# WOLF CREEK NUCLEAR OPERATING CORPORATION

ET 09-0030

Subject: Docket No. 50-482: Application To Revise Technical Specification 3.8.4, "DC Sources – Operating," Surveillance Requirements (SR) 3.8.4.2 and SR 3.8.4.5

**Subject:** Revision to Technical Specification 3.8.4, "DC Sources – Operating," Surveillance Requirements (SR) 3.8.4.2 and SR 3.8.4.5

Figure 1

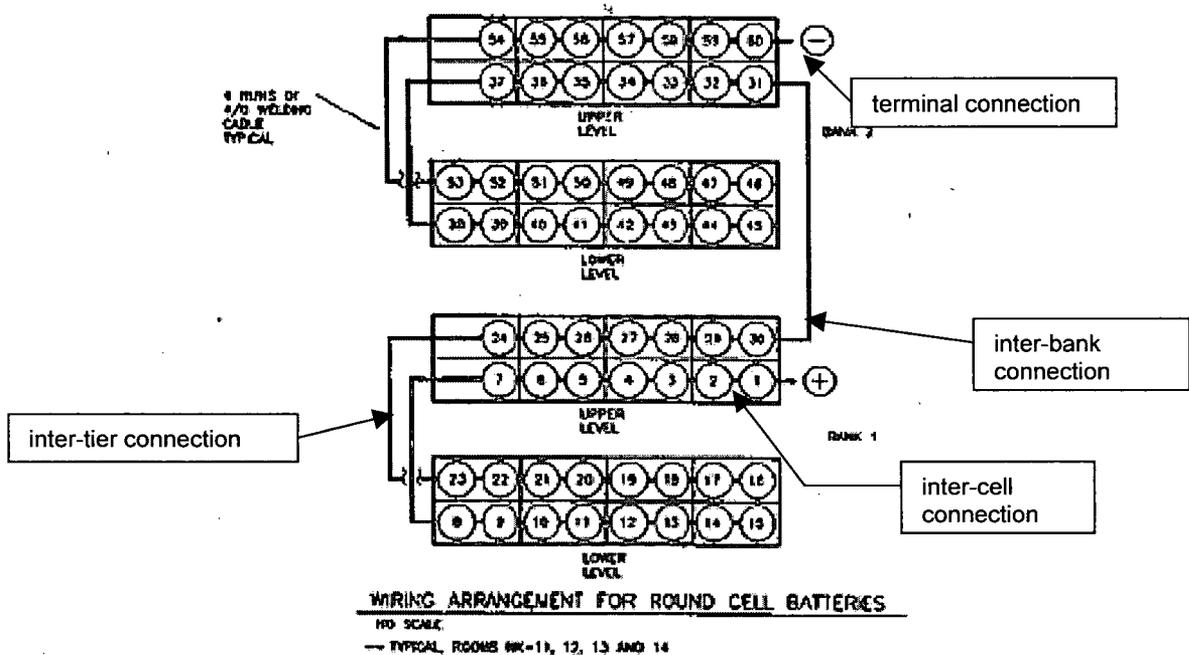
The Train A and Train B batteries are formed by strings of battery cells. These strings are comprised of a series connection of the positive and negative terminal posts of adjacent cells as shown in Figure 1. The inter-cell connections, inter-rack connections, inter-bank connections, and terminal connections contribute to the total battery connection resistance, which reduces the overall battery terminal voltage. During normal operation of the battery, corrosion can occur on the battery posts, which can also increase the connection resistances and further reduce battery terminal voltage.

Service conditions dictate that, due to physical limitations and practical considerations, battery cells be arranged in tiers and banks. The resistance value of each inter-tier and inter-bank connection may differ from the inter-cell connection resistance values of the battery cells. Each battery is physically arranged into two thirty-cell banks with the associated inter-bank connection. Each bank consists of two tiers: a sixteen-cell lower tier and a fourteen-cell upper tier. Each thirty-cell bank has 27 inter-cell connections and two inter-tier connections.

NK Battery Round Cell Connection Arrangement  
Typical for NK-11, -12, -13, and -14  
(No scale)

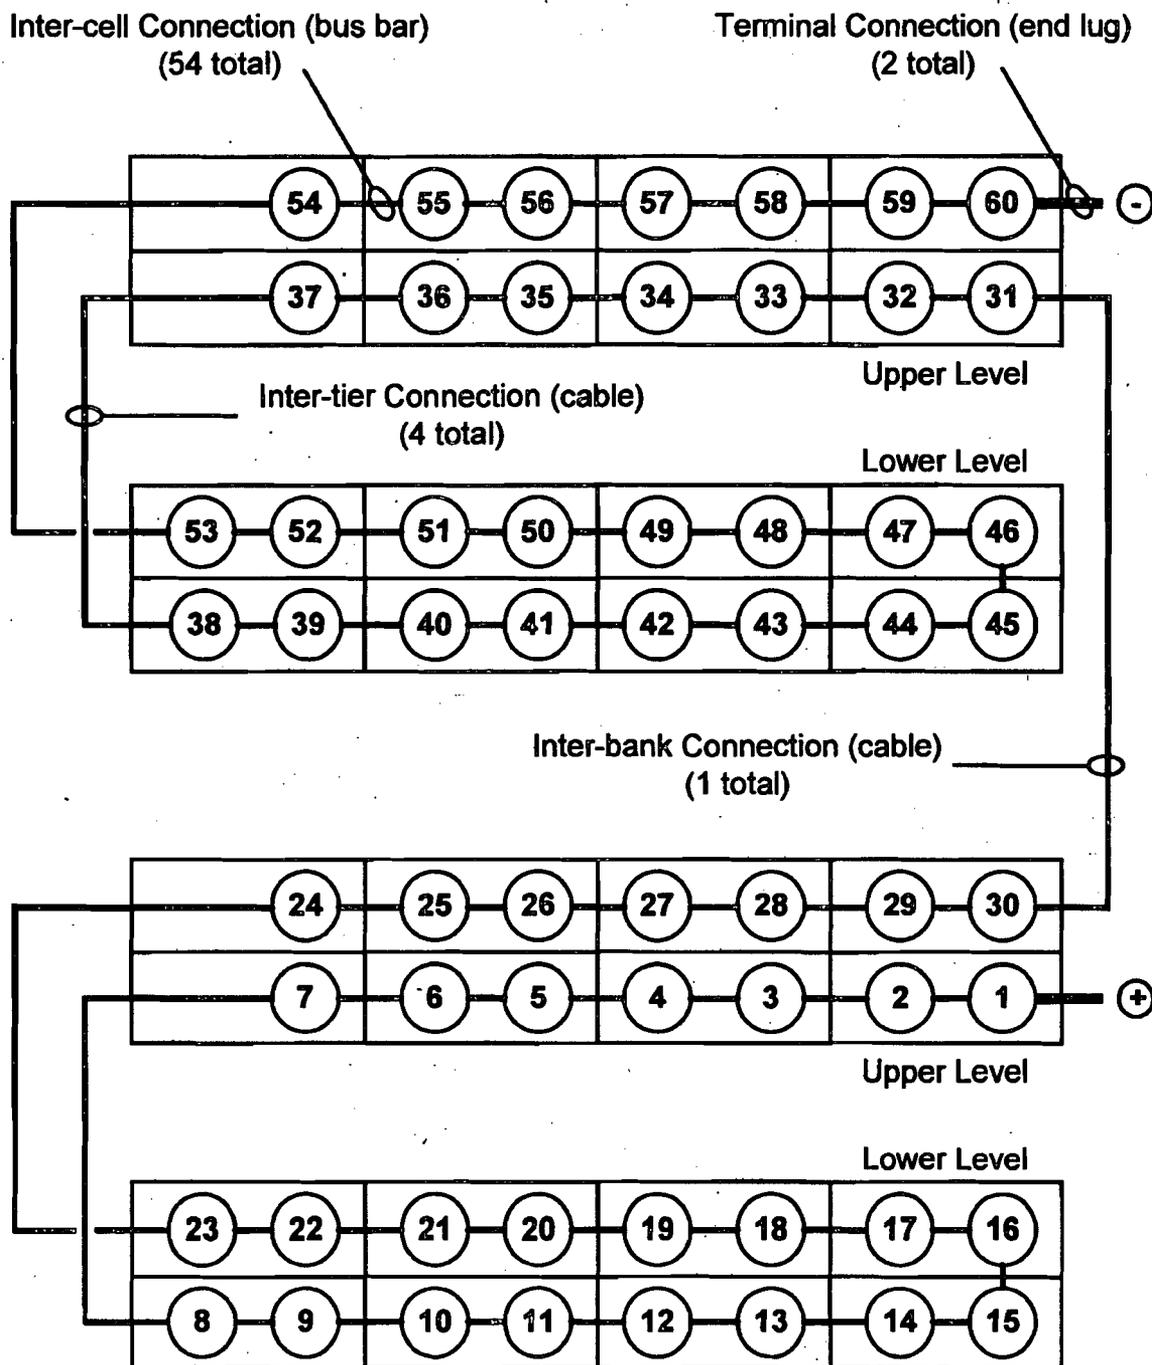
1. Refer to Attachment A for a typical NK Battery System cell-connection arrangement.
2. Calculation No. NK-E-002-004-CN007 (Reference 3) established  $48 \mu\Omega$  as the suitable battery "Inter-cell connection resistance" design\* value. For a normal 60-cell Battery System configuration, Reference 3 also established  $2,832 \mu\Omega$  ( $= 59$  Inter-cell connections  $\times 48 \mu\Omega$ ) as the design\*\* value for the "Maximum Calculated Total Battery Connection Resistance" (i.e., the maximum allowable cumulative sum of the combined connection resistances).
